**Proposed Temporary Warehouse (excluding Dangerous Goods Godown) with Ancillary Facilities
and Associated Filling of Land for a Period of 3 Years in "Agriculture" Zone,
Lot 207 in D.D. 38, Man Uk Pin, New Territories**

(S.16 Planning Application No. A/NE-MUP/235)

GEOTECHNICAL PLANNING REVIEW REPORT (GPRR)

Response to CEO, CEDD comments on 25 June 2026.

FIGURE 1

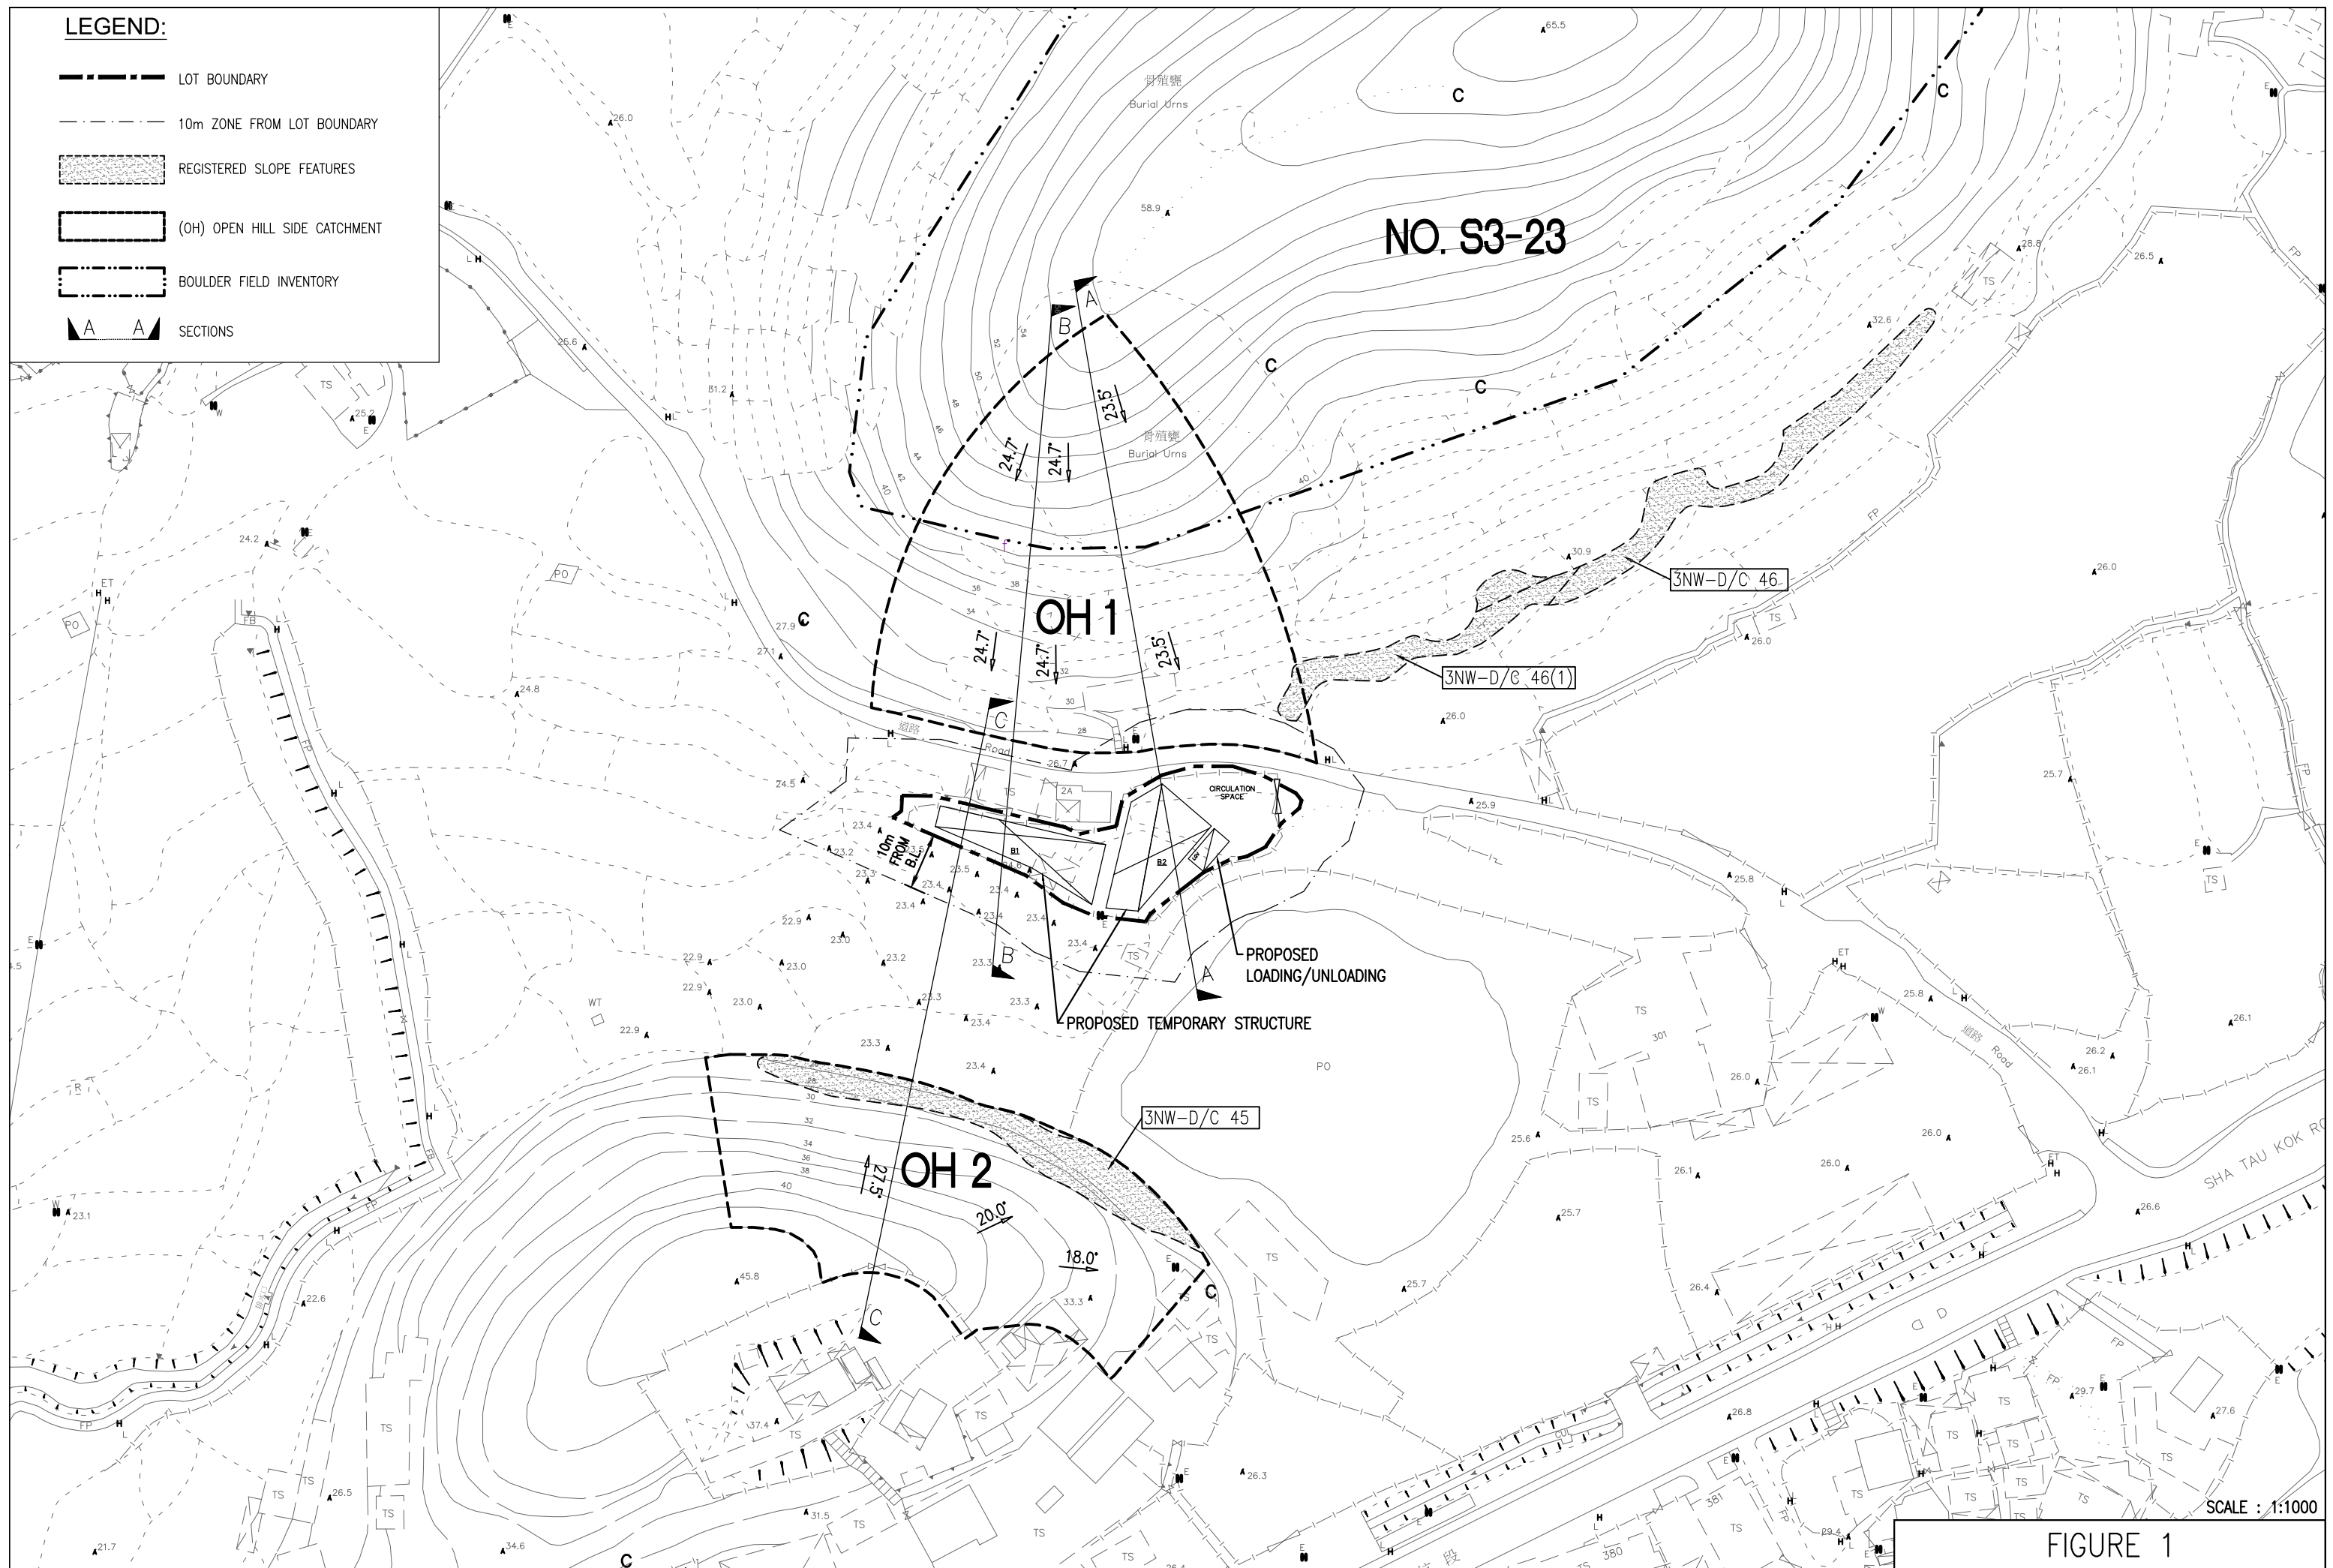
Comment from GEO, CEDD	Response to Comment (R to C)
The subject site is overlooked by steep natural terrain and meets the alert criteria for a natural terrain hazard study (NTHS);	Noted. This Report has been prepared in accordance with GEO Report 136.
Given the temporary nature and the proposed use as warehouse of the subject site, the requirement for NTHS might make the case not economically viable. As an alternative, the northern part of the subject site may be designated as a ‘no-build’ zone, within which no critical facilities (i.e. facilities under Group 1 to 3 in the attached table at Appendix II) should be located. In particular, the proposed site office, washroom, parking space and manned structure (if any) should be located away from the ‘no-build’ zone. The suggested extent of the ‘no-build’ zone is shown in the attached plan. With the inclusion of the ‘no-build’ zone, the requirement for NTHS may be waived;	Noted. Since the indicated no-build zone will render the development totally ineffective and impractical, we propose that an NTHS shall be carried out to the Study Area proposed in Section 4.3 of this Report.

Refer to 6.3.4. of GEO Report138, it is proposed the hillside catchment OH(1) shall be carry out further study. The extent of natural terrains affecting the Site to be studied is demarcated in Figure 6.

This subject Site is overlooked by an open hillside terrain with hillside pocket along its foothill area, also it falls within Polygon No.S3-23 of Boulder Field Inventory. It is recommended that a Natural Terrain Hazard Study (NTHS) shall be carried out to the proposed Study Area attached in Figure 6.

Appendix C

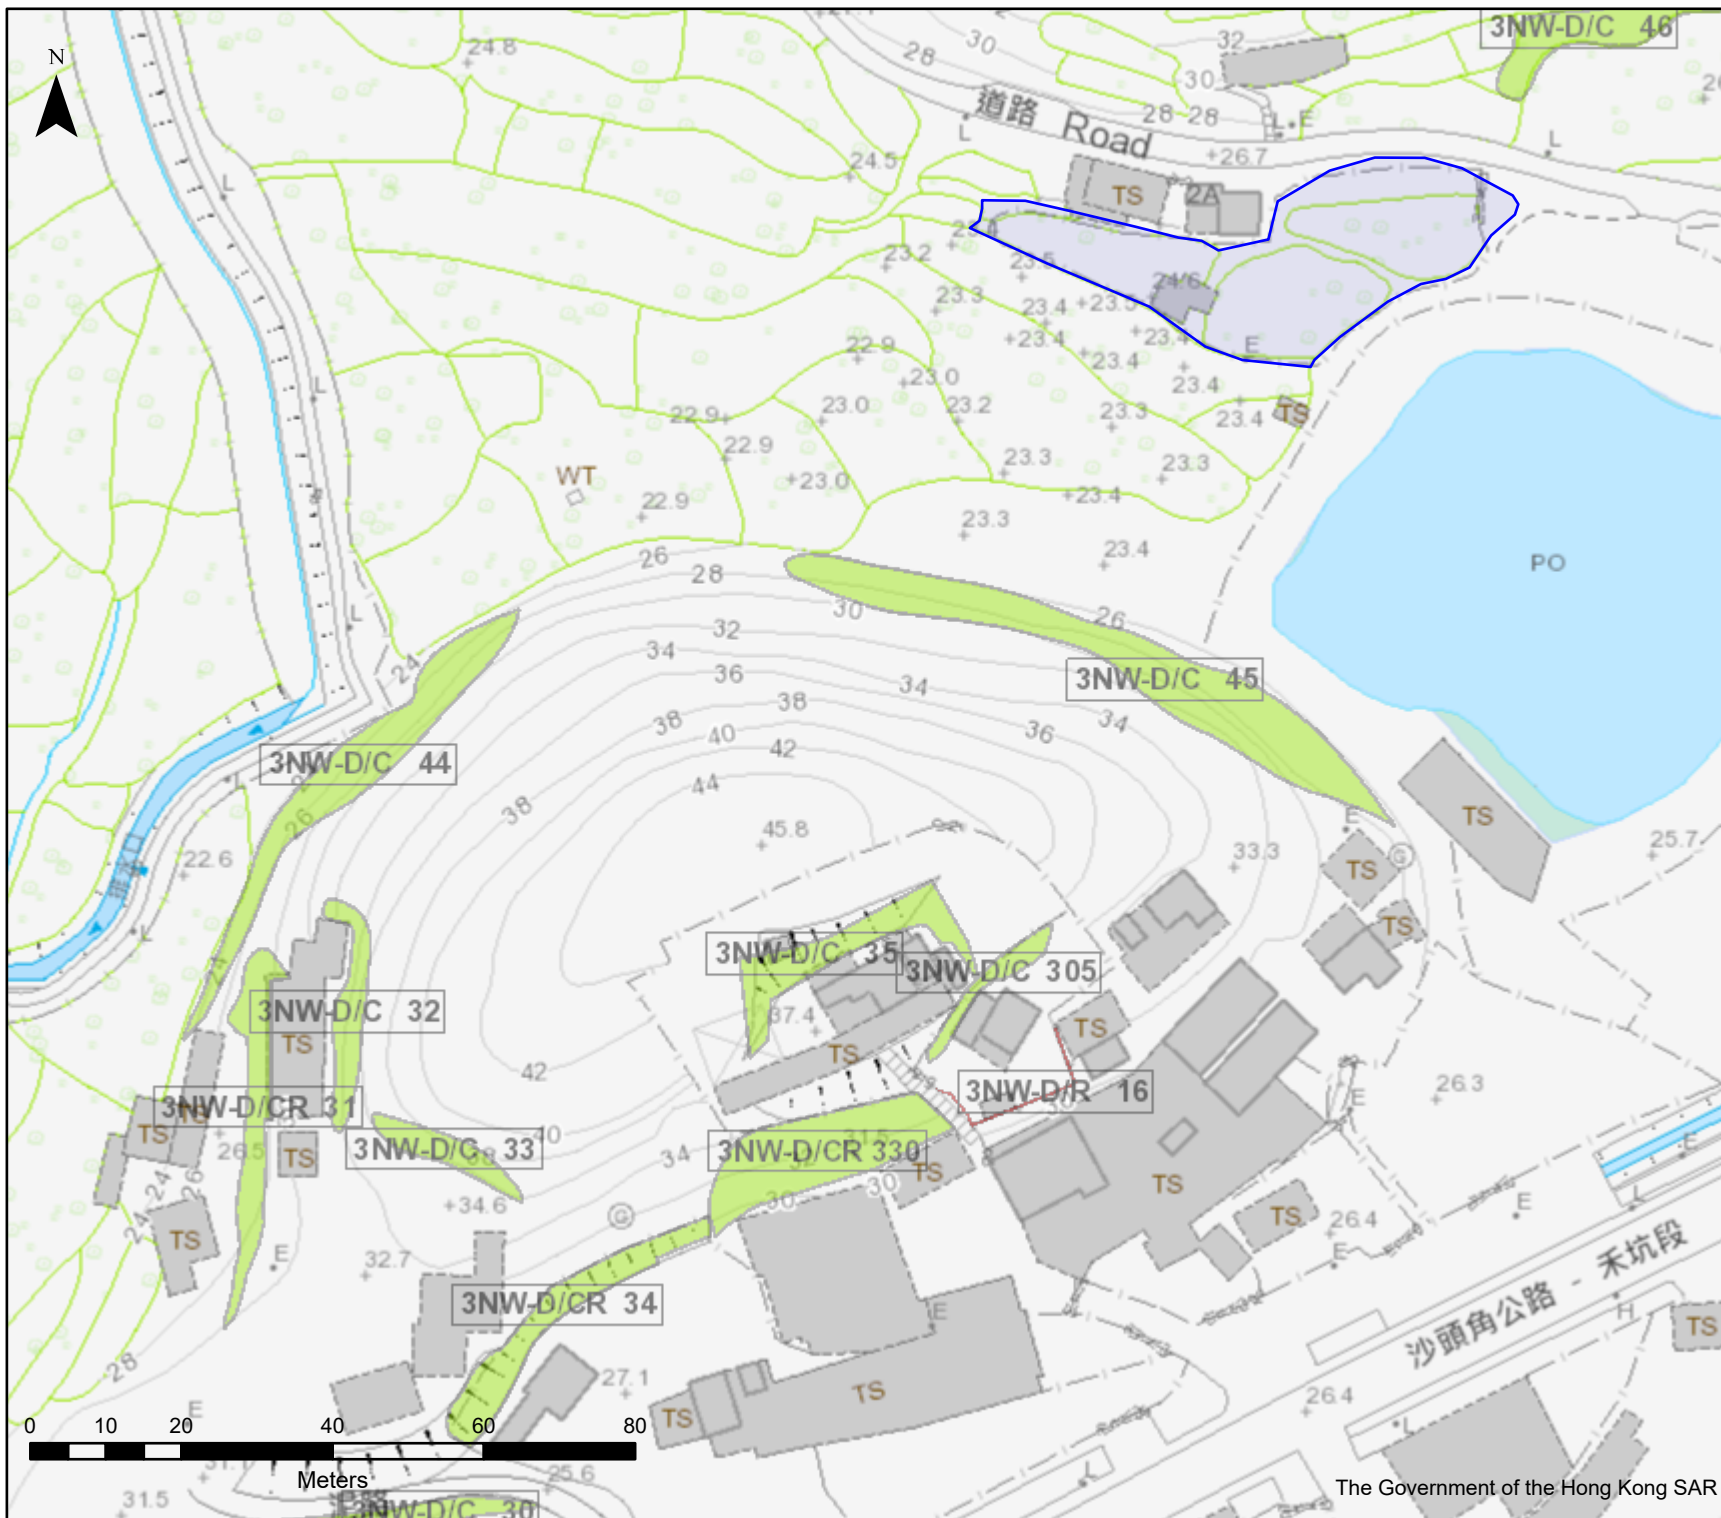
Section 3.1.1 of the GPRR - there is no alluvium within the subject site according to the geological map in Appendix C of the GPRR. the applicant should revise;	Noted. The top layer of soil should be Colluvium. Section 3.1.1 is revised accordingly.

Based on Glnfo Geological Map of Solid Geology, there is no available ground investigation results within the Site and its adjacent area (sheet 3 of geological map), the Site is lying on Debris Flow Deposits (Qpd) stratum, the top layer of soil would be colluvium.

Appendix E

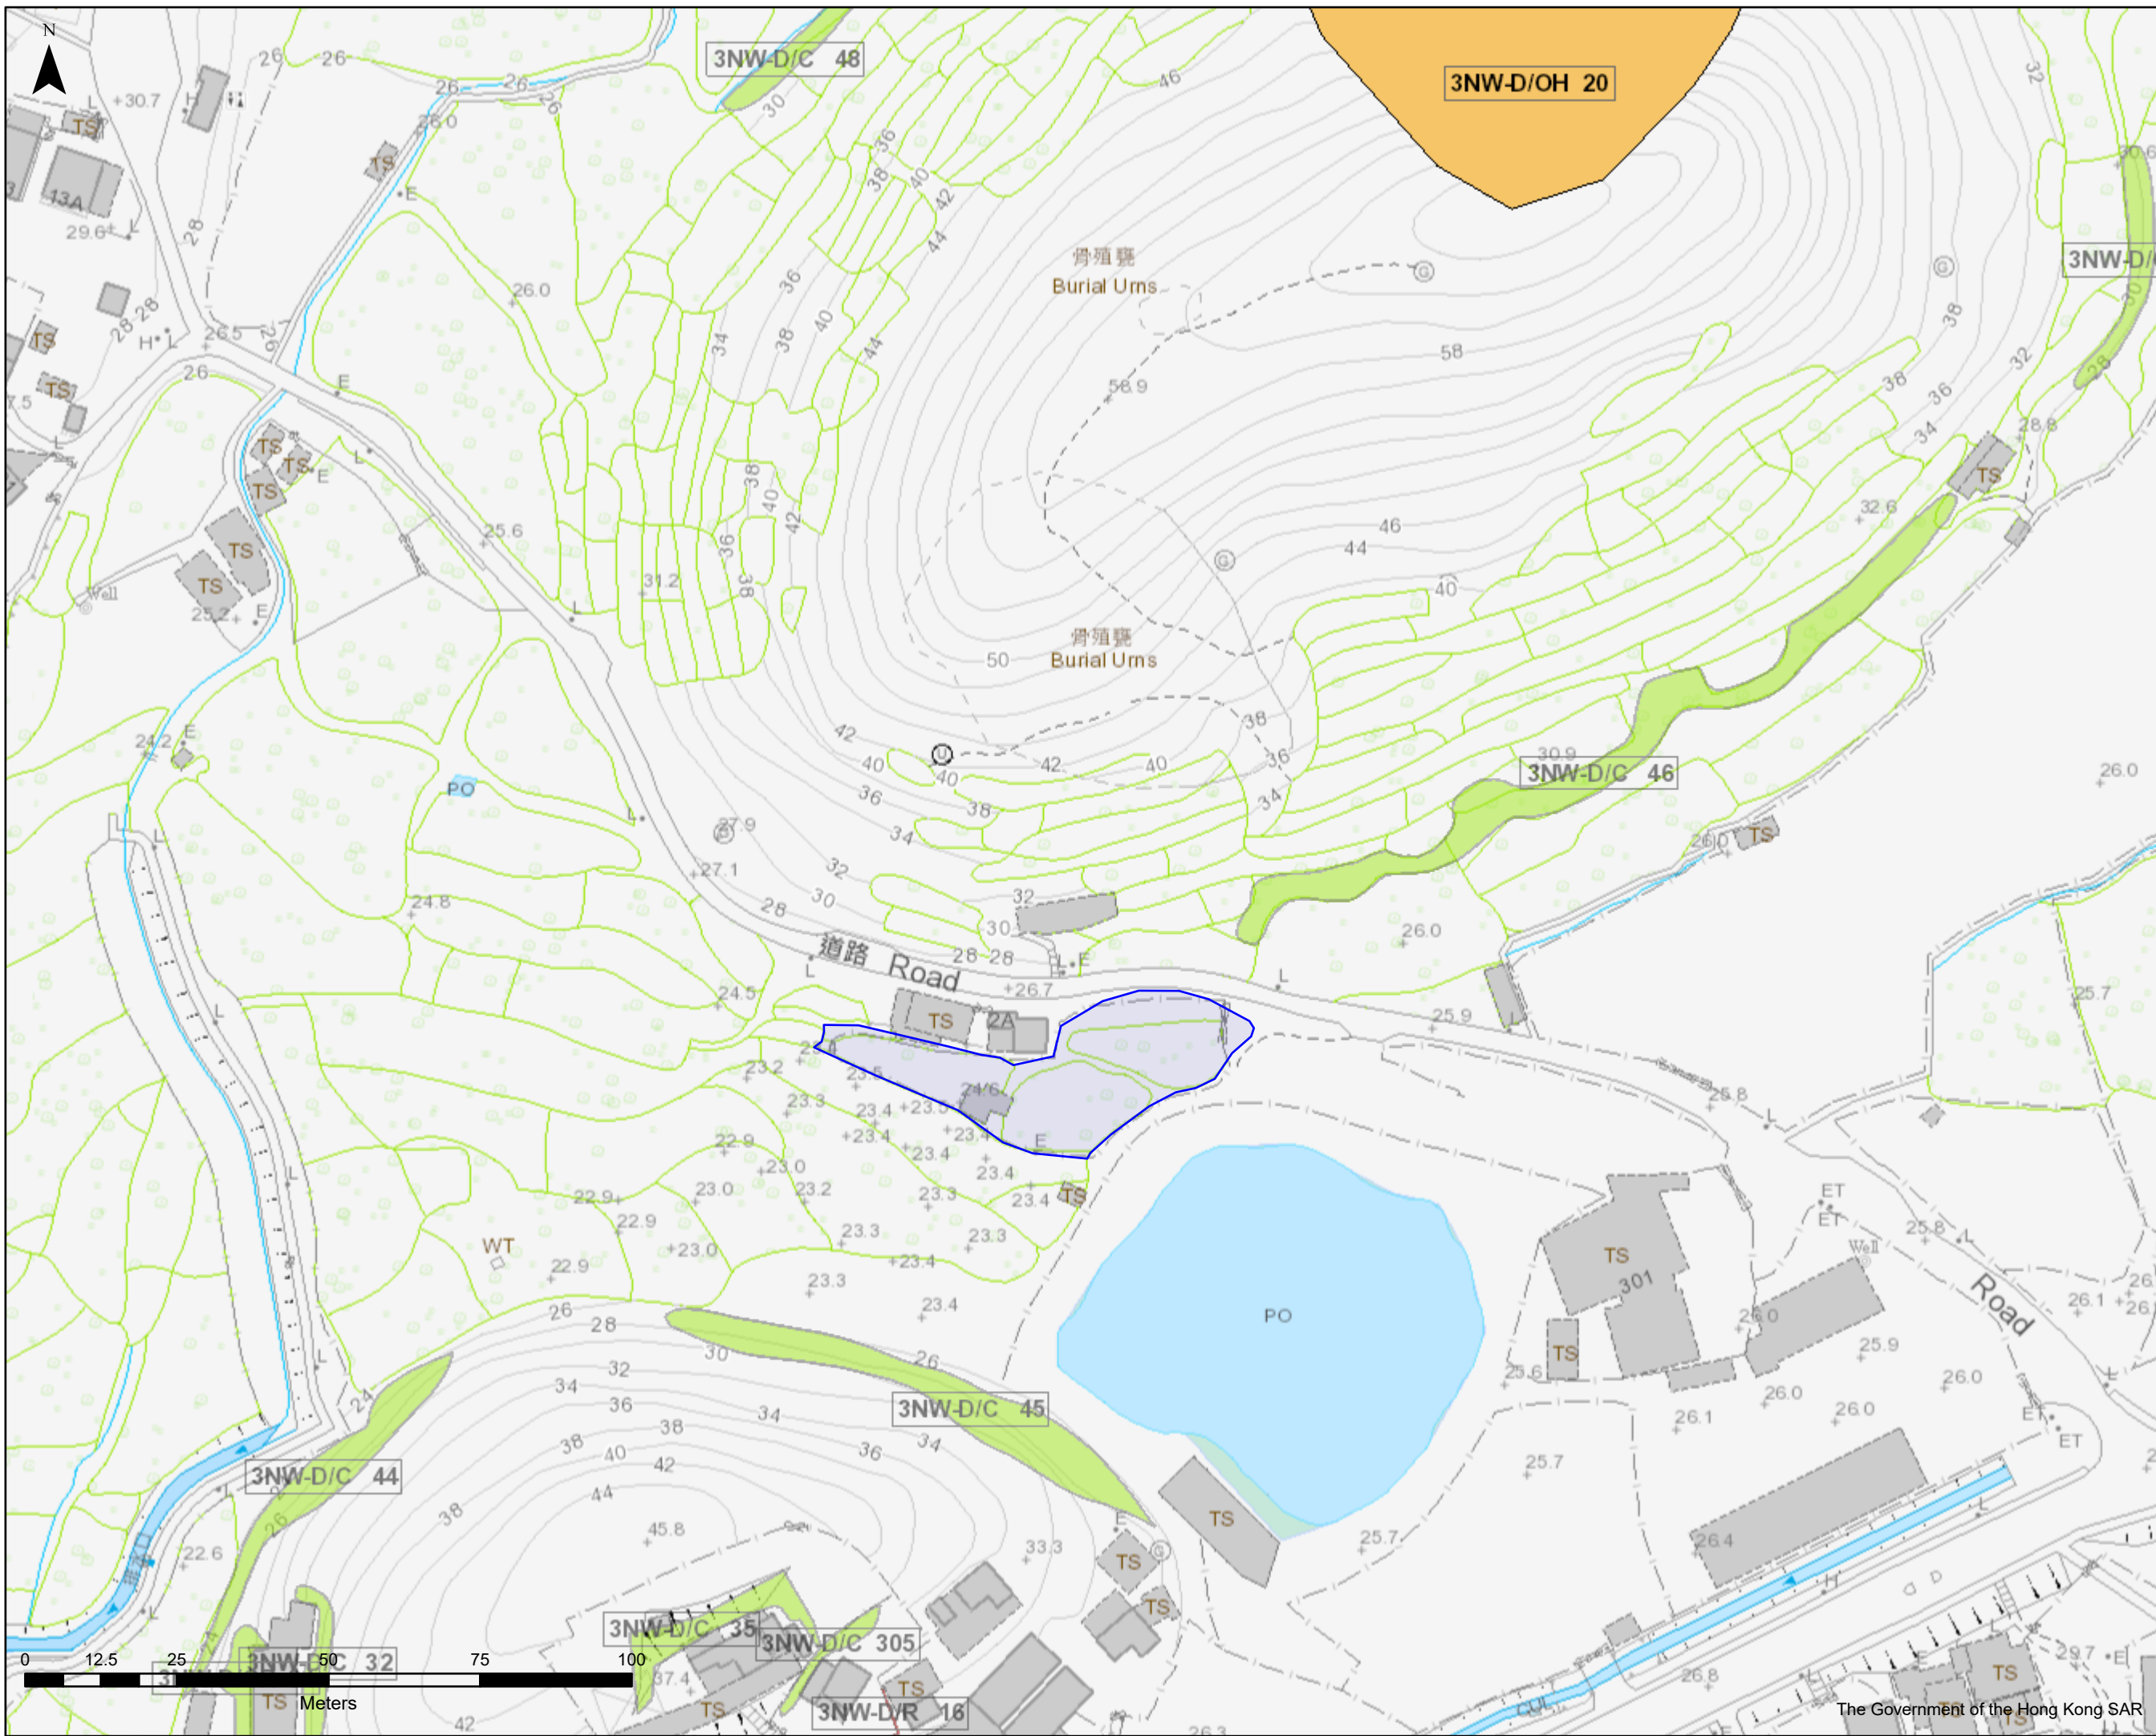
Section 3.1.3 of the GPRR - the applicant should discuss the boulder field inventory information for the natural terrain overlooking the subject site;	Noted. The discussion of boulder field inventory information has been revised accordingly in Section 3.1.3.
section 4.2.1 of the GPRR - relaxation of angular elevation of the Alert Criteria from 20 degrees to 25 degrees could not be applied for the natural terrain to the north of the subject site as the natural terrain is affected by human disturbance (e.g. terraces) and is considered to be a Hillside Pocket; and	Noted. The angular elevation of the Alert Criteria is revised to 20 degrees.
Section 4.2.2 of the GPRR - the applicant should discuss the facility group of the proposed site office, washroom and parking space of the proposed use.	Noted. Referring to the revise Layout Plan, only Loading/Unloading space (LGV) and warehouse for goods storage are proposed. The discussion of the facilities are revised in Section 4.2.

The Site itself not fall in any Boulder Field Inventory but Catchment OH1 (Natural openhill terrain) is fall within Polygon No.S3-23 of the Boulder Field Inventory. The extent of Boulder Filed Inventory is shown in **Appendix E**.
